## IGNITION SWITCH / 1974 FX, FXE, XL, XLCH

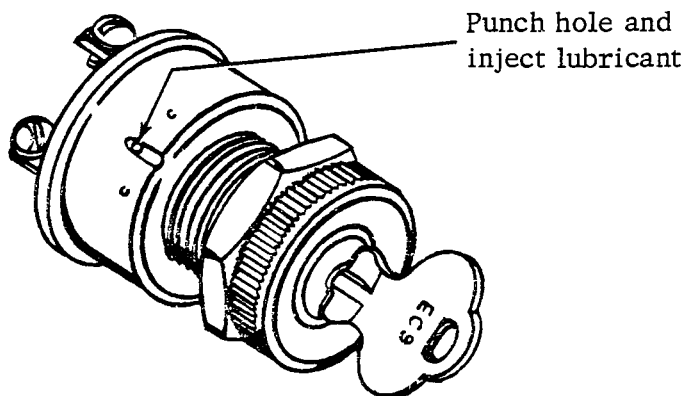
Due to a production oversight on 1974 models, lubricant was omitted on the ignition key switch indexing plate, which could cause the switch to bind.

The lubricant can be injected into the switch after removing the switch from the vehicle and punching a small hole in the notched area as shown below.

To remedy or prevent a binding problem, lubrication with a silicone lubricant is recommended.

If this lubrication injection doesn't remedy the binding, inject lubricant into the 1/8" tumbler lubrication hole located in the mounting nut thread area.

Continued binding indicates switch is defective and should be replaced using Part No. 71500-59A.
